April 16, 2010  
NRC3-10-0016

Subject: Detroit Edison Company Response to NRC Request for Additional Information Letter No. 25

**Response to RAI Letter No. 25  
(eRAI Tracking No. 4339)**

**Figure II.1-2  
Design and Construction Organization**

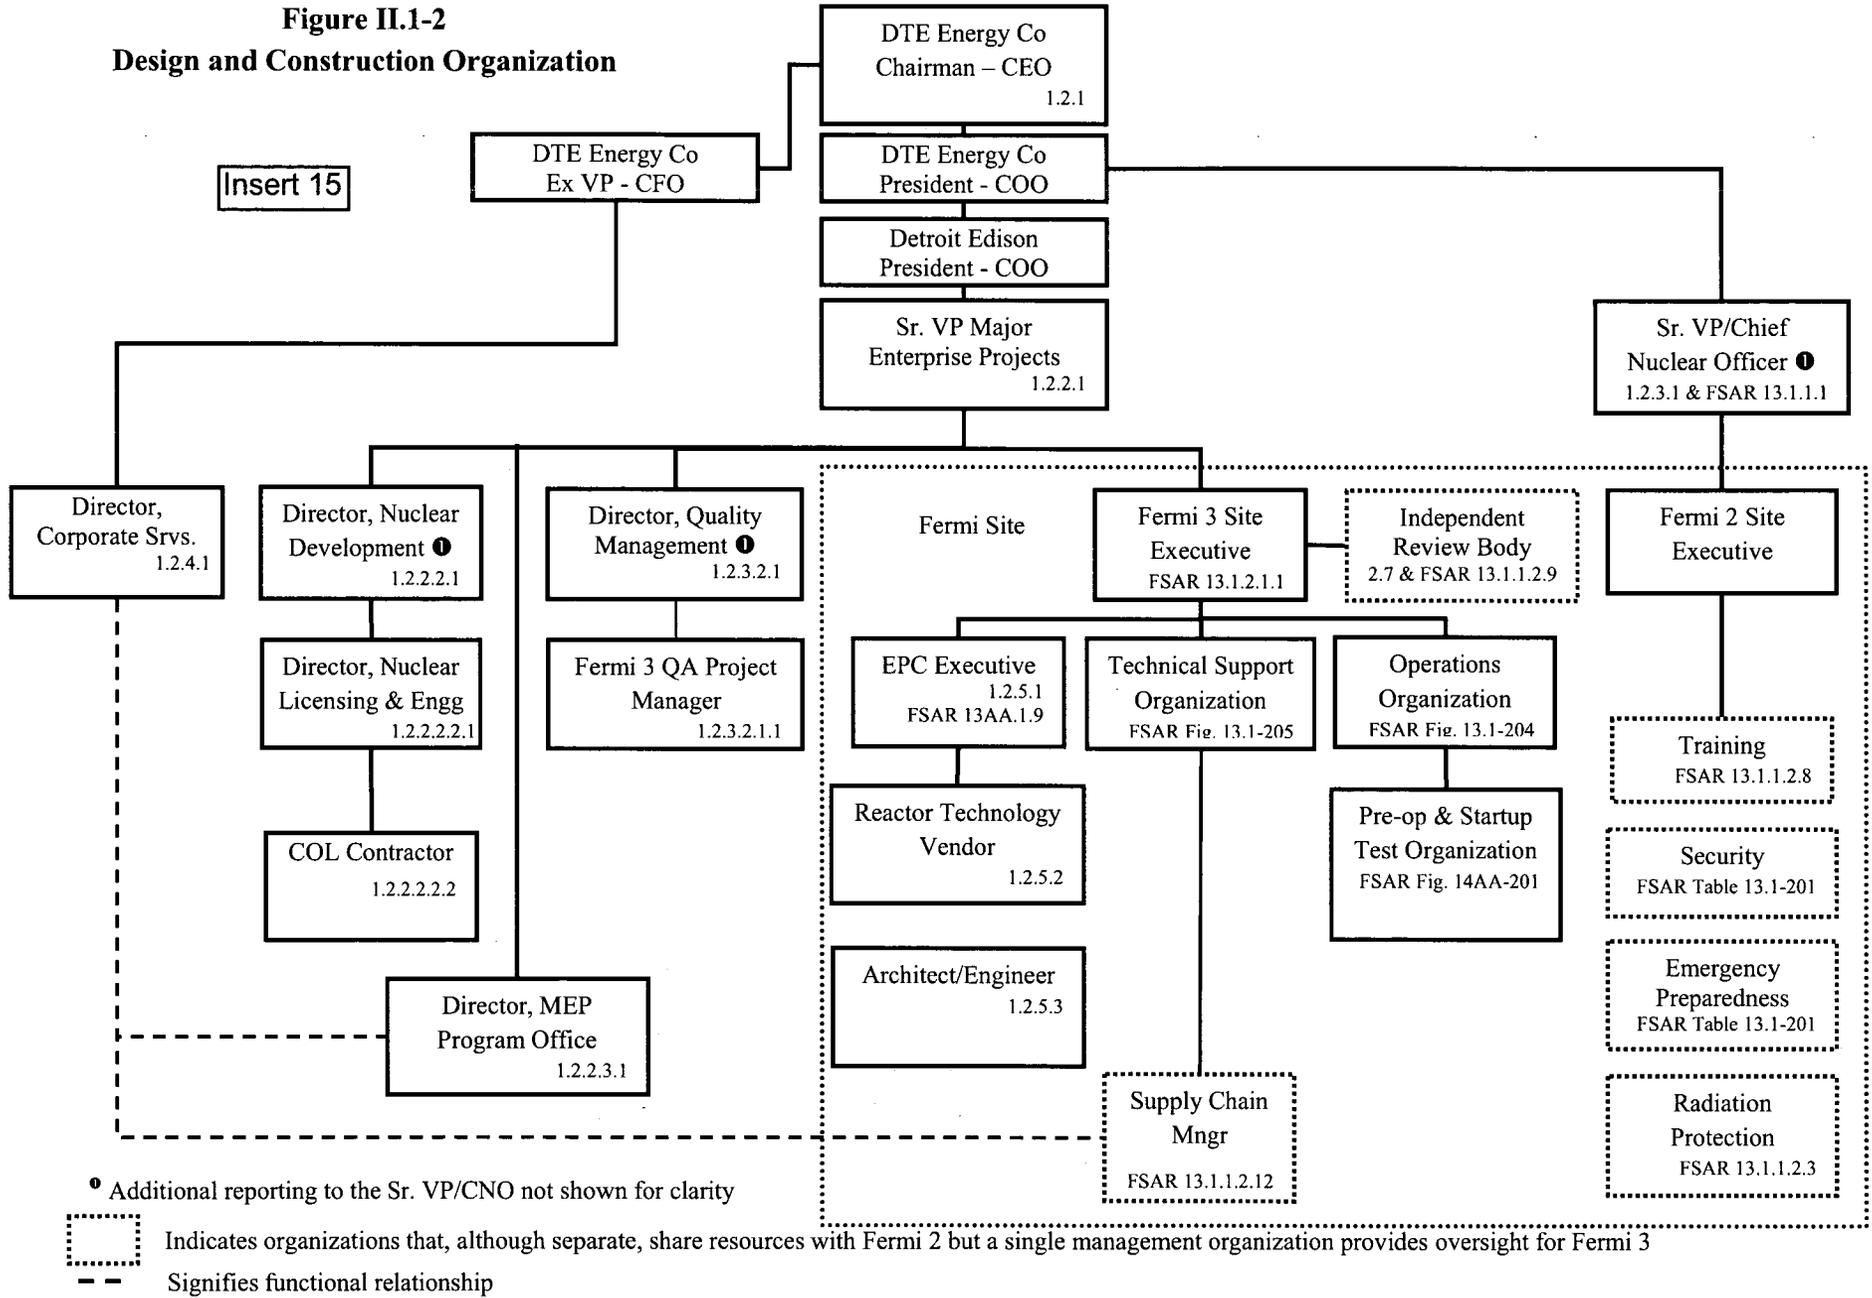
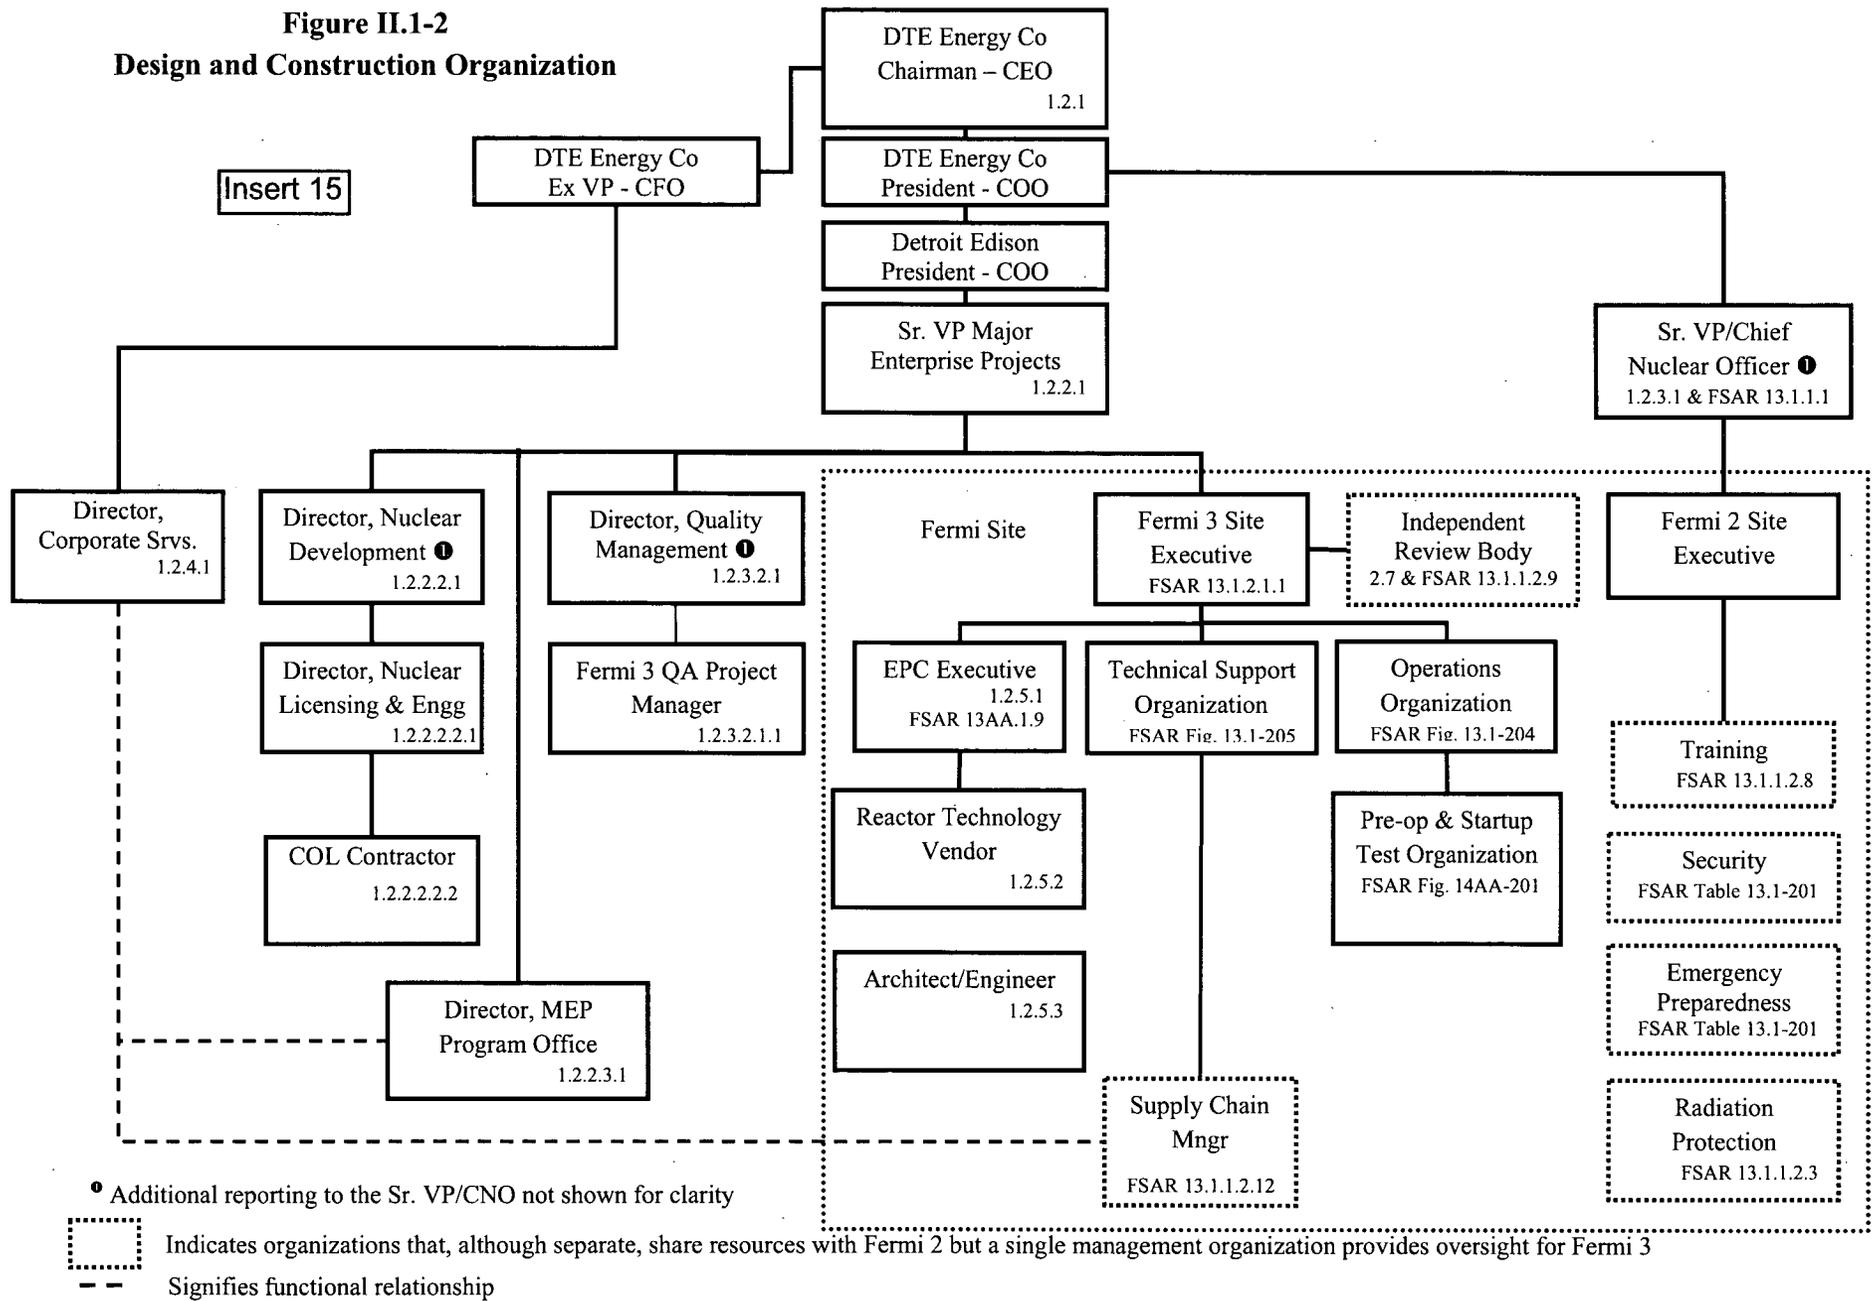
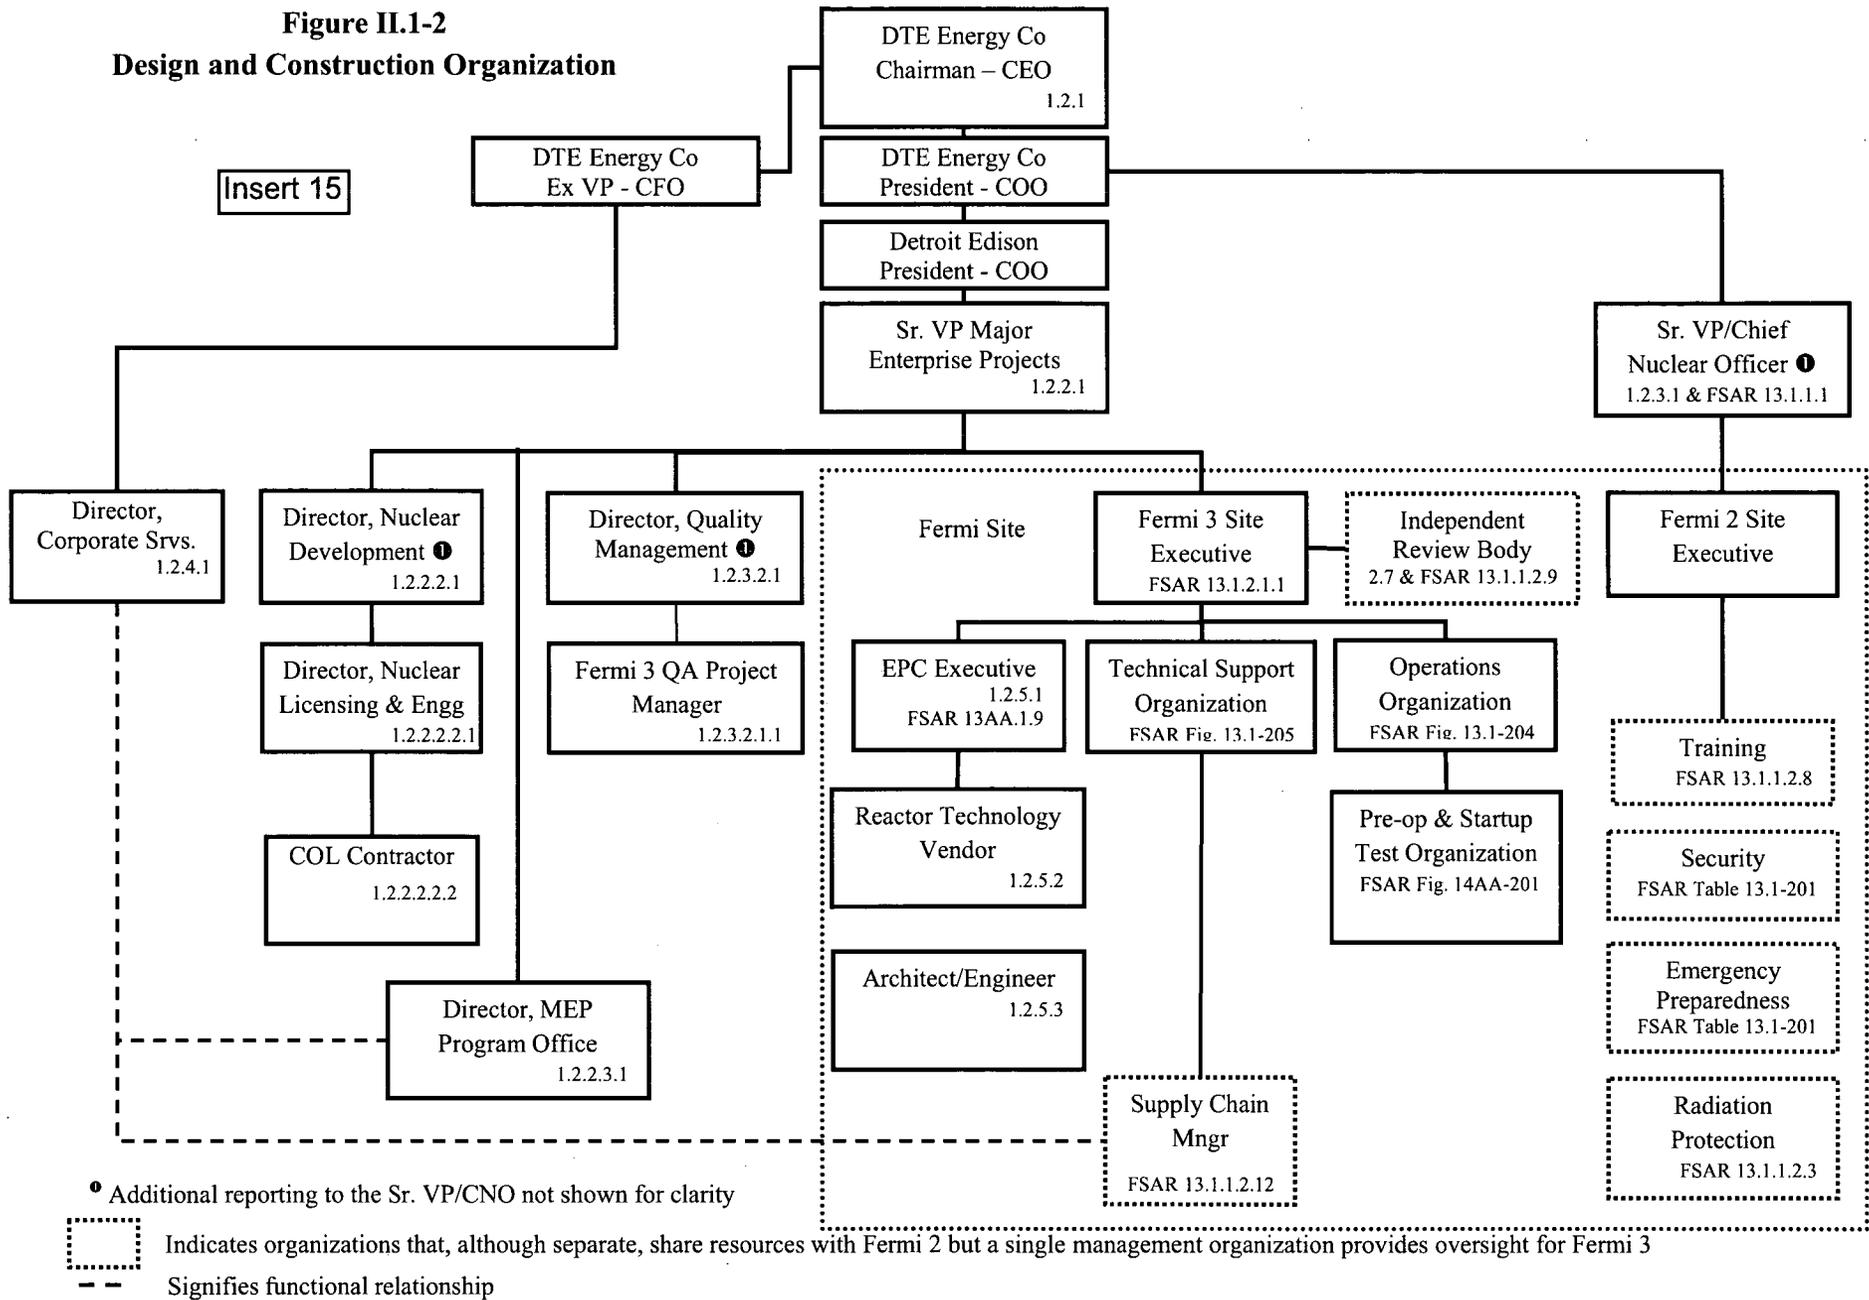
The organizational description presented in Appendix 17AA includes the onsite and offsite organizational elements that function under the cognizance of the Fermi 3 QA program. FSAR Figure 13.1-201 and QAPD Figures II.1-2 and II.1-3 have been revised to identify those organizational elements that are on the Fermi site.

Appendix 17AA, Figure II.1-1, "Fermi 3 Pre-COL Organization", and Figure II.1-2, "Design and Construction Organization" have been revised to provide the interfaces for each of the primary contractors, the reactor technology vendor, the COLA contractor and the EPC contractor as shown in the attached markup. The markup to Appendix 17AA, "Fermi 3 Quality Assurance Program Description" provided with RAI 17.5-12 in Attachment 10 also reflects these changes.

Appendix 17AA, "Fermi 3 Quality Assurance Program Description" Figures II.1-2 and II.1-3 are being revised as shown in the attached markup. Appendix 17AA Figures II.1-2 and II.1-3 are also included in the markup provided with the response to RAI 17.5-12 in Attachment 10.
